**Proposal for amendment to Regulation No. 46  
(Devices for indirect vision)**

**I. PROPOSAL**

Figure 1

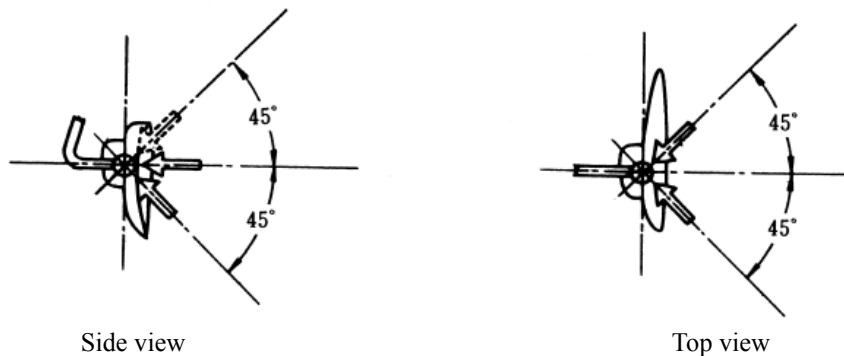
6.1.3.4.1. Static Test (a)

In the case of the exterior mirror, apply a rearward force in a direction parallel to the vehicle centre line, to the centre of the rear-view mirror's direction-swivel section (or to the centre of the outermost mirror's direction-swivel section if more than one mirror is supported by the same mounting section, or to the centre of the mirror body if there is no direction-swivel section). However, if the centre of the rear-view mirror's direction-swivel section is located inside the vehicle's outermost side in the vicinity of the mirror mounting area, or that centre is located at a height of more than 2.0 m above the ground, the force may be applied to any part of the mirror body that protrudes further than the vehicle's outermost side in the vicinity of the mirror mounting area.

In the case of the interior mirror, apply a forward force in each of the following directions, to the centre of the rear-view mirror's direction-swivel section (see Figure 1):

- \* Direction parallel to the vehicle centre line,
- \* Directions 45° to the left and right of the vehicle centre line on the horizontal plane, and
- \* Direction 45° upward or downward of the horizontal line on the vertical plane parallel to the vehicle centre line.

To allow the static test that is almost equivalent to the dynamic test.

Figure 2

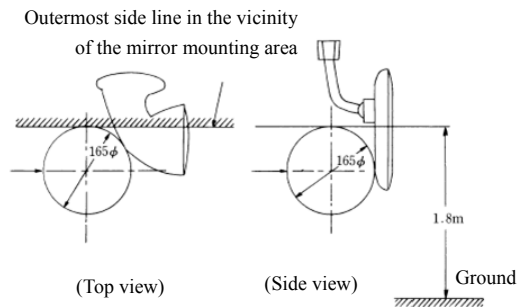
6.1.3.4.2 Static Test (b)

In the case of the exterior mirror, place a 165 mm diameter cylinder in such a way that the exterior of the cylinder comes in contact with the vehicle's outermost side line in the vicinity of the mirror mounting area, or the line drawn at a height of 2.0 m above the ground. Apply a rearward force in a direction parallel to the vehicle centre line, to the cylinder centre line (see Figure 2).

Figure 3

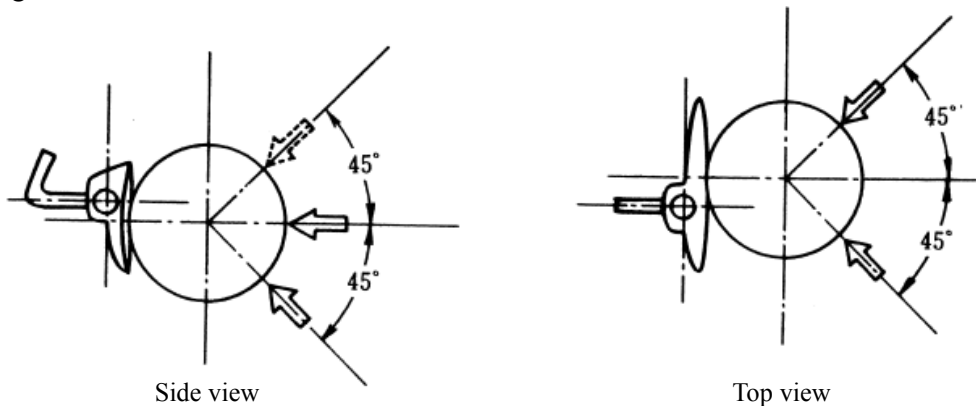
In the case of the interior mirror, place a 165 mm diameter spherical object in such a way that it comes in contact with the mirror surface centre, and apply a forward force in each of the following directions, to the spherical object centre (see Figure 3):

- \* Direction parallel to the vehicle centre line,
- \* Directions 45° to the left and right of the vehicle centre line on the horizontal plane,
- \* Direction 45° upward or downward of the horizontal line on the vertical plane parallel to the vehicle centre line.

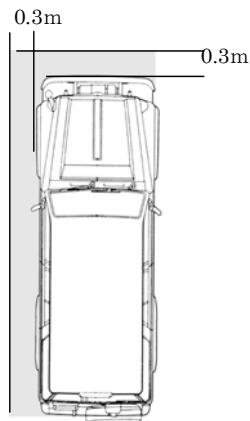
"15.2.2.2. Exterior mirrors shall be visible through the side windows or through the portion of the windscreen that is swept by the windscreen wiper, **except for the areas on the mirror surface that are not specified as visible areas.** Nevertheless, for design reasons, this last provision (i.e. the provisions relating the cleaned part of the windscreen) shall not apply to:

(a) exterior mirrors on the passenger side and optional exterior mirrors on the driver side of vehicles of categories M2 and M3;

(b) Class VI mirrors. "

It is not necessary to include areas that are not specified as visible areas in the areas to be swept by the windscreen wiper.

Figure 1

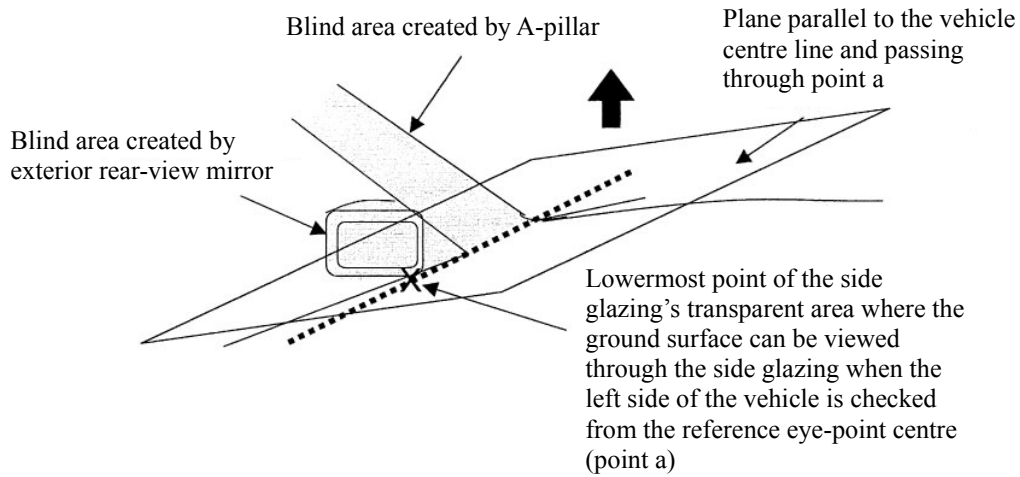
2. Range of the blind area created by the A-pillar or exterior rear-view mirror  
The range of the blind area created by the A-pillar or exterior rear-view mirror in paragraph 15.2.4.10. shall be an area that meets the following formula. In this case, if there is more than one blind area, each blind area must meet the conditions of the formula.

$$X \leq 0.292L - 0.203$$

X (m): Limit of the excluded area. Distance between the centre of a cylinder in

contact with the front edge of the blind area and the centre of a cylinder in contact with its rear edge.

L (m): Located inside the blind area created by the A-pillar or exterior rear-view mirror. Distance between the rear edge of a cylinder in contact with the rear edge of the blind area and the front edge of the rear wheel.
